# PARTS & SERVICE NEWS

Ref. No.	AH98025
Date	07.10.1998

**Subject:** Connector for multi-purpose bucket and hose protector

**Application:** WA75-3 / WA85-3

Modification of the quick attach coupler:

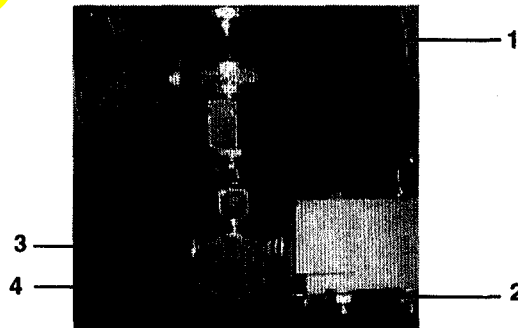
**Purpose:** Modification of connector for multi-purpose bucket and additional hose protector

**Description:** In the further of technical development the left quick attach coupler from the additional control circuit and the long hydraulic hose from the multi-purpose bucket was been modified.  
If required we recommend this additional modification.

- Set the change over lever into its position "2"
- Rebolt the quick-change unit remove the hydraulic hose from the quick attach coupler.
- Remove the hydraulic pipe (1) from the block.
- Remove the bracket with (2) with block and coupler from the boom.
- Remove the bracket (2) from the block.
- Screw on the new bracket (Pos. 1) on the block.
- Remove the circlip (3).
- Remove the quick attach coupler (4).
- Set on the spring (4) put the straight end of spring into the 4 mm-hole of the new bracket.
- Set on the quick attach coupler (4).
- Mount the circlip (3).
- Screw on the bracket with block and coupler on the boom and tighten.
- Screw on the hydraulic pipe (1) at the block.

- Set the hose protector (Pos.3) onto the hose
